# UNITED STATES PATENT AND TRADEMARK OFFICE

APPLICATION NO.	FILING DATE	FIRST NAMED INVENTOR	ATTORNEY DOCKET NO.	CONFIRMATION NO.
09/492,369	01/27/2000	William E. Blaha		9790

# Office Action Summary

EXAMINER'S ATTACHMENT

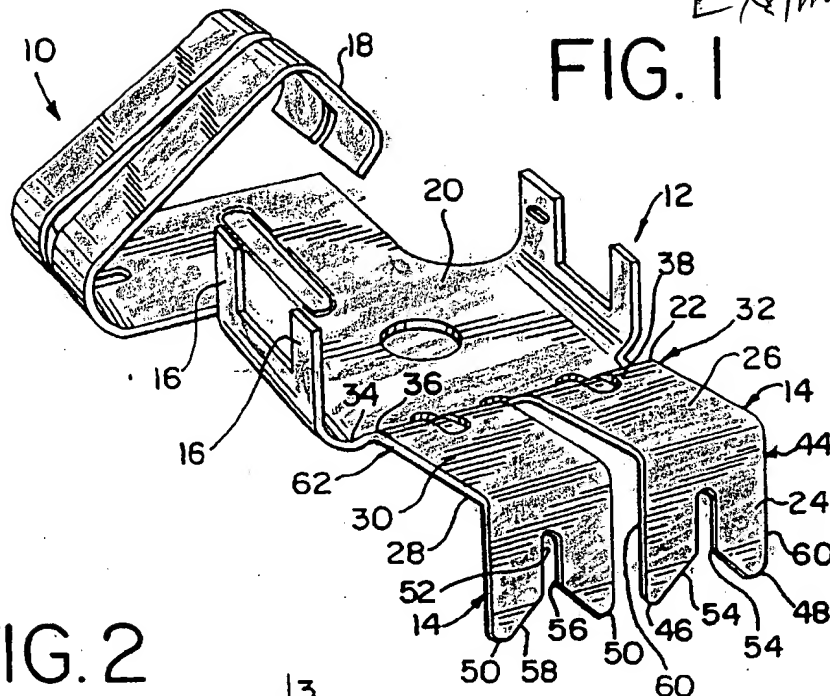
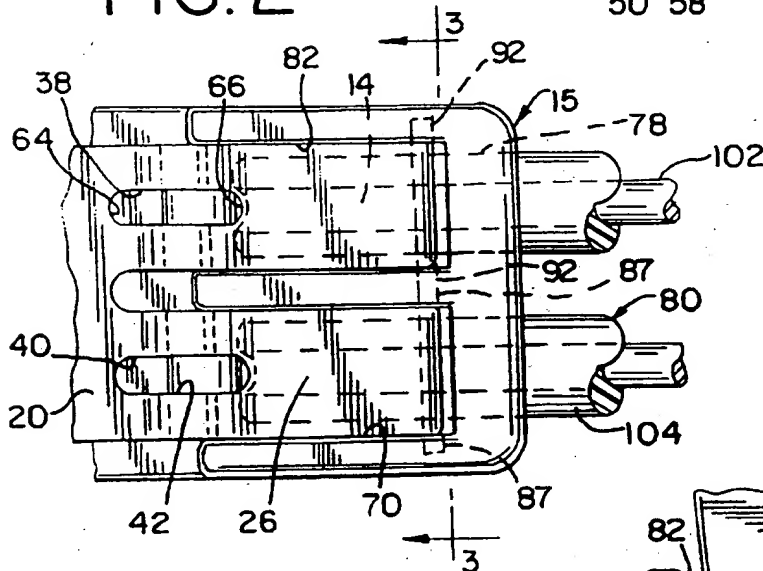
Regarding claims 1-2 and 5, Sowinski discloses a wire connector (10) comprising:

a housing (15) define cavity (70) therein with openings (78);

an electrically conductive clip (red portion, see Examiner's attachment) having at least first and second retaining finger (14, 14) forming an insulation displacement type contact, each of which engages an individual conductor (80); and

a blade-type electrically conductive extension (blue portion, see Examiner's attachment) in shorting electrical engagement with the clip and extending through a

housing wall to an exterior of the housing, at least a portion of the extension on the exterior of the housing being electrically conductive.
